#### Re: San Onofre spent fuel pool cooling system and chiller waivers 9-15-0417-W and 9-15-0162-W

## EDISON ANSWERS AND MY NEW COMMENTS AND QUESTIONS IN [BLUE BRACKETS]

Figure 2:
SONGS Independent Spent
Fuel Cooling Island

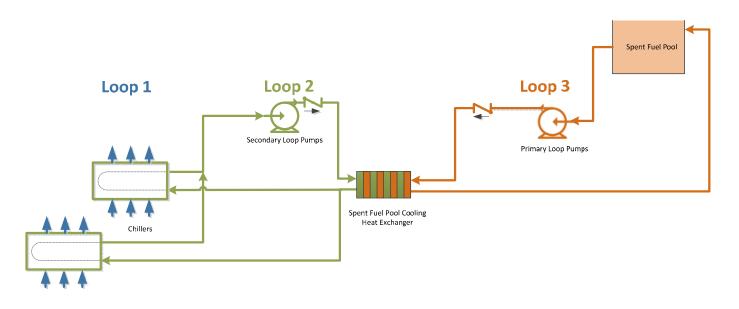
5Q: What is the source of the water? How will this impact our local water supply? [Given the new water requirements by Governor Brown's executive order, how does this comply with that or does it? What city is supplying the water? Have they been notified of the increase need for 900 gallons per week of city water?]

13Q: How is this a closed-loop system? The pools are in a building that is subject to evaporation.

A: The proposed Spent Fuel Pool Island cooling system is composed of two (2) separate water loops. The secondary loop will continuously circulate fresh water through the chillers to the secondary side of the new Spent Fuel Pool Heat Exchanger and back through the chiller (Figure 2). It requires an initial system fill of approximately 1000 gallons, which will come from the city supplied service water system. In contrast, the existing secondary cooling system is a once through system passing approximately 16,000 gallons per minute of ocean water. The proposed Spent Fuel Pool Island cooling system is essentially a 'closed' system in that it does not require a continuous supply of once-through cooling water; however, it does require makeup as described below.

The primary loop will continue to operate in the same manner as it does now. Water from the Spent Fuel Pool is circulated through the primary side of the new Spent Fuel Pool Heat Exchanger and is returned to the pool. This loop is **currently** subject to **evaporative losses of approximately 900 gallons per week [city water vs. ocean water]** and **will not change** with the new Spent Fuel Pool Island cooling system. The source of that makeup water will continue to be our demineralized water system, which ultimately gets water from the city supplied service water system. Makeup needs will continue to decrease as the fuel continues to cool.

A diagram of the proposed Spent Fuel Pool Island cooling system consisting of two cooling loops is presented as Figure 2. A composite rendering of the proposed equipment superimposed on an existing plant photo is provided in Figure 3.

# Figure 3 (rendering):

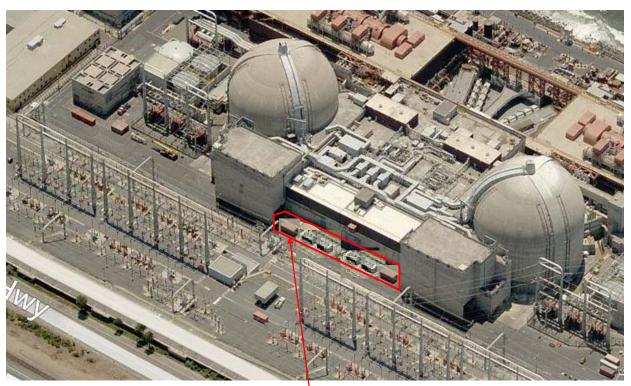
2. Plans/diagrams of the chillers and of the full SFPI system once installed.

# **Equipment Description Trane 200 Ton Chiller Unit**

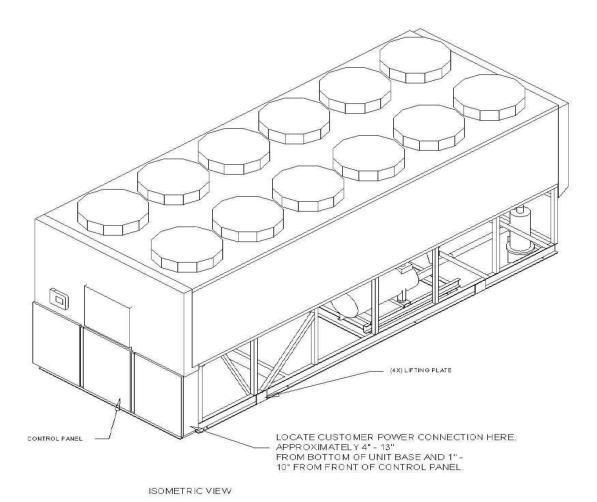
14Q: What are the system redundancies? What are the single points of failure? [This is inadequate redundancy.] [For example: No current redundancy of chillers. What is the guaranteed delivery time of a replacement chiller?]

- 1. The make and model of the chillers proposed for use in the system, and their technical specifications. [Make, but not model numbers are on the Enclosure]
  - A: Specifications of the chillers including make and model are provided in Enclosure 1.

Two 200-ton capacity air cooled chillers will be used within a closed loop cooling system utilizing potable water on the secondary side of the temporary fuel pool cooling system for SONGS Unit 2 and SONGS Unit 3. The designed criterion is based on information provided by SONGS of a heat load calculation of three million BTU/hr per fuel pool. Each chiller will be a 200-ton unit designed to remove 2.4 MBTU/hr and have the ability to be cross connected so the entire heat load of Units 2 and 3 spent fuel pools can be removed by three chillers. This will give SONGS the needed contingency in case of equipment shutdown due to the unlikelyhood of equipment failure or scheduled maintenance. The cooling water will leave the chillers and flow through a plate frame heat exchanger that will pull heat from the primary loop and return back to the chillers. Chillers will require 460 VAC power. The chillers will be limited to a return temperature of 100°F due to relief valves on the refrigerant side of the unit, which will lift at 108°F and release Freon into the atmosphere.
